Access Compliance Report Public Rights-of-Way (Curb Ramps)

Main Street: S_SELLAS_RD		Cross Street: ABELIA_ST		Location:	NW
ADA ID: RPAT211102140739	Ramp Type: Type 4 - Parallel	Initial Pass/Fail: Fail	Overall Compliance: No	Severity Score:	15
Codes/Mitigation Info/Possible Solution			Field Measurements/Component Compliance

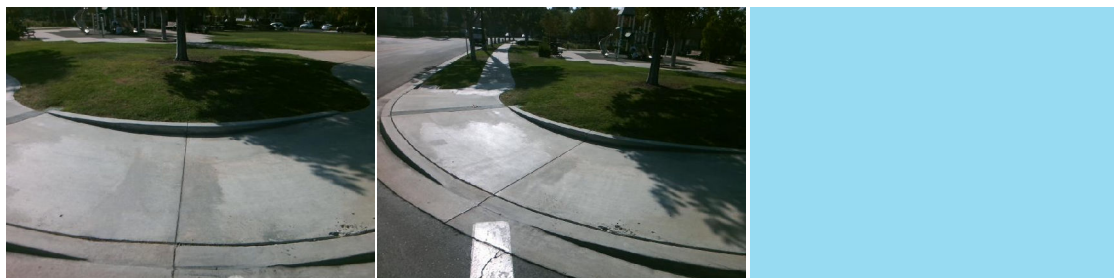
R204.3, R304.3.2, STD 1115

Remove & Replace Curb Ramp With Two New Directional Ramps or Equivalent.
